# Fixing A Corner Case in the Link Monitor State Diagram

July 15, 2019

Figure 149-33 Link Monitor

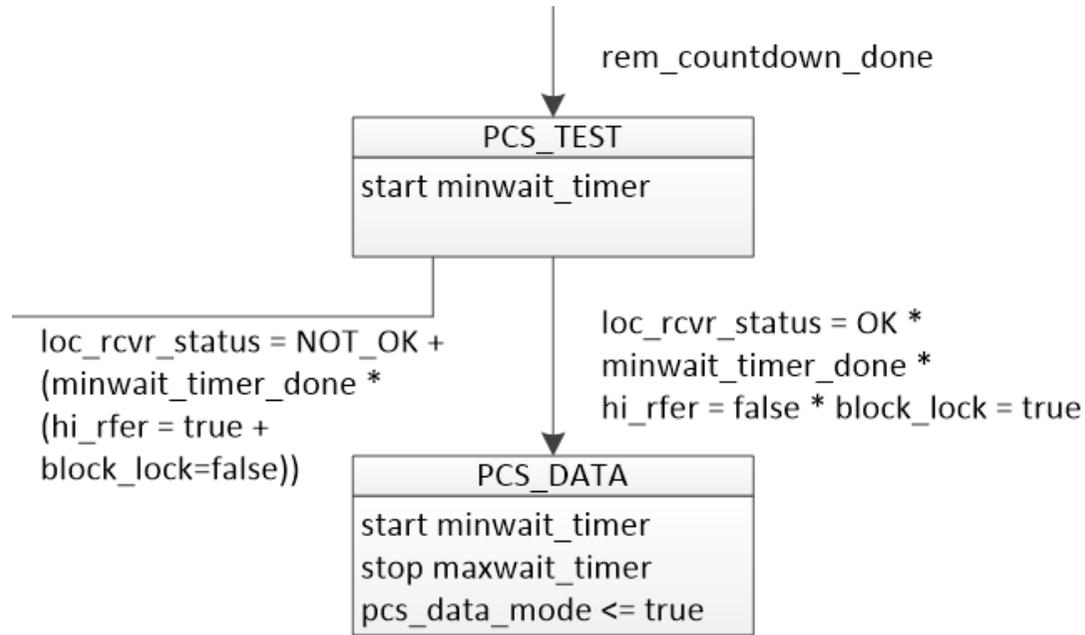
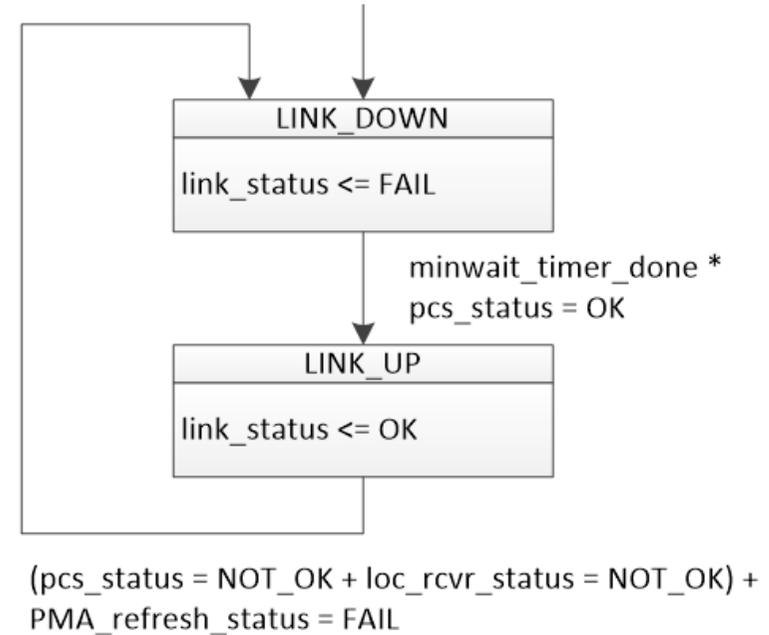
- PHY Control enters from PCS\_TEST into PCS\_DATA
  - pcs\_data\_mode becomes true → pcs\_status becomes OK
  - minwait\_timer is started
- Corner case: before minwait\_timer expires, the pcs\_status is lost due to loc\_rcvr\_status=false or hi\_rfer=true
  - Link Monitor state machine never goes into LINK\_UP state → excessive delay to restart training

Figure 98-7: autoneg

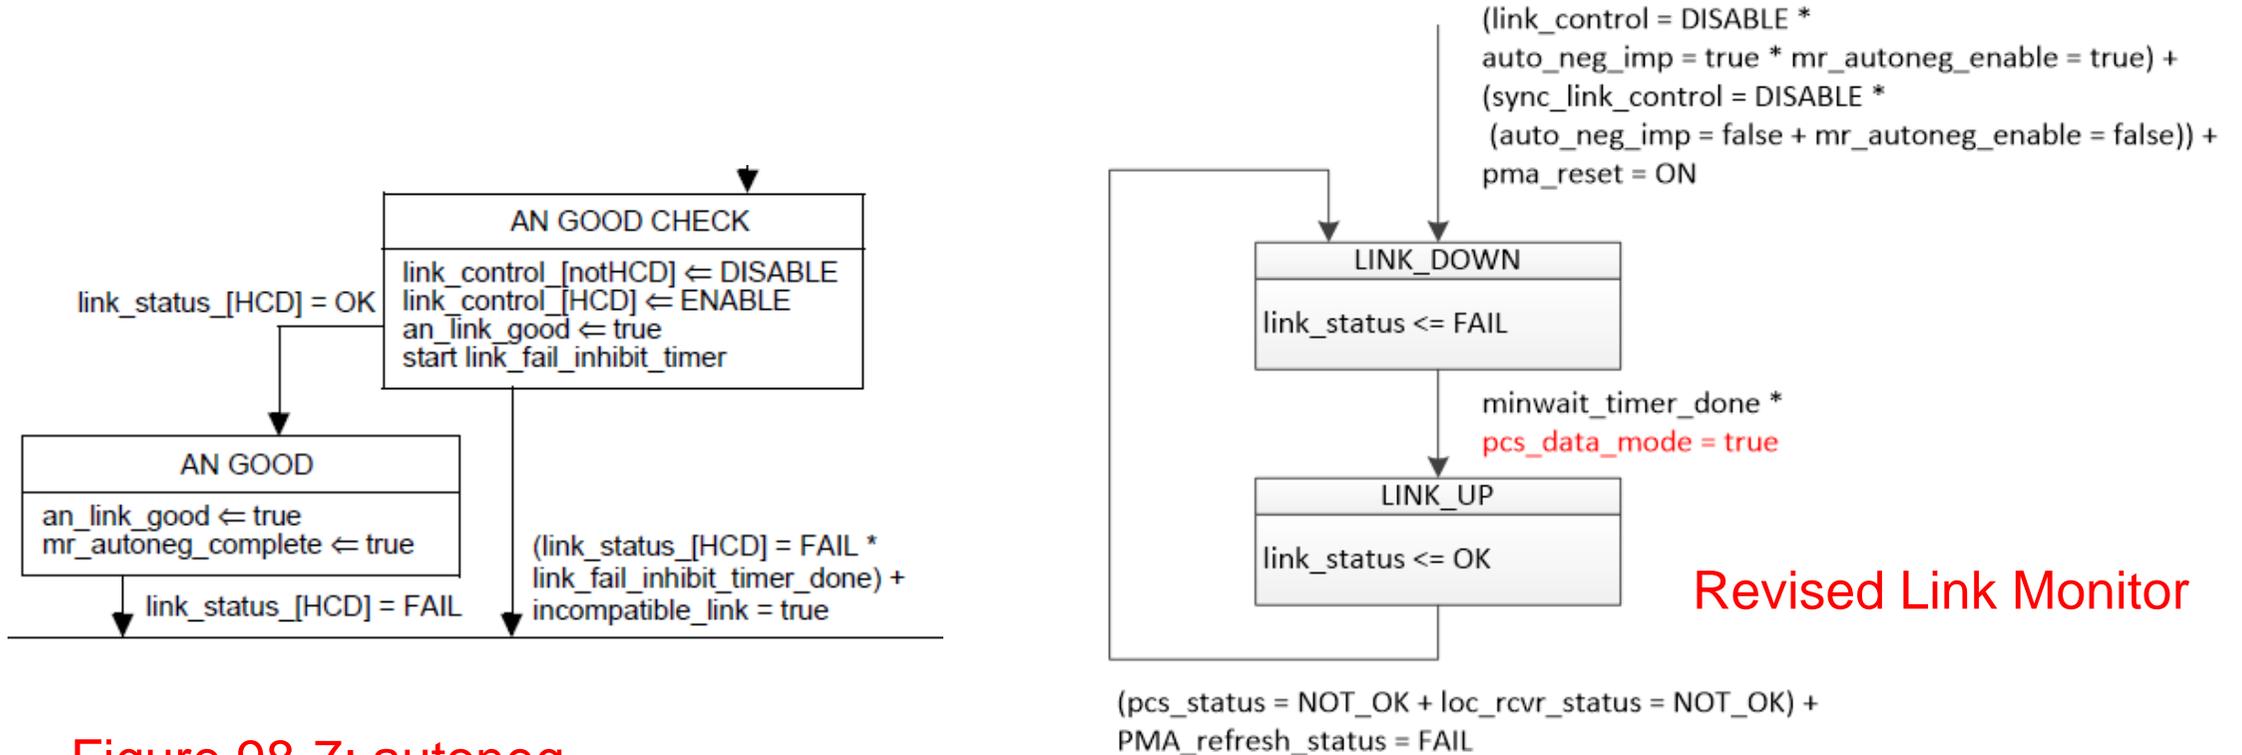
- In Link Monitor, enter the LINK\_UP state based on “pcs\_data\_mode = true” instead of “pcs\_status = OK”.
- This allow autoneg state machine to enter the “AN GOOD” state.
- Any problem in pcs\_status or loc\_rcvr\_status will cause Link Monitor to go from LINK\_UP into LINK\_DOWN
- The autoneg state machine will then restart autoneg right away, without delays

# Figure 149-34 Changes

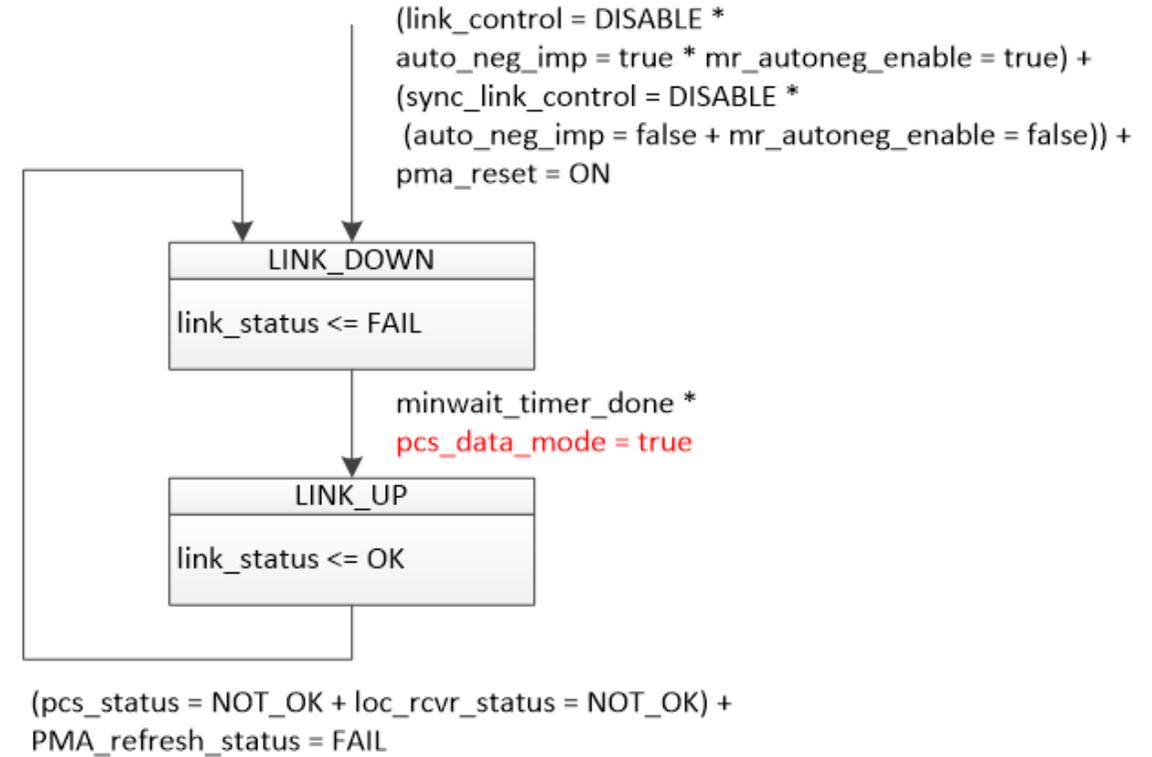
- Page 154, Line 12, 149.4.5, Figure 149-34
- Change the transition condition from the LINK\_DOWN state to the LINK\_UP state:
  - From
    - “minwait\_timer\_done \* pcs\_status = OK”
  - To
    - “minwait\_timer\_done \* pcs\_data\_mode = true”
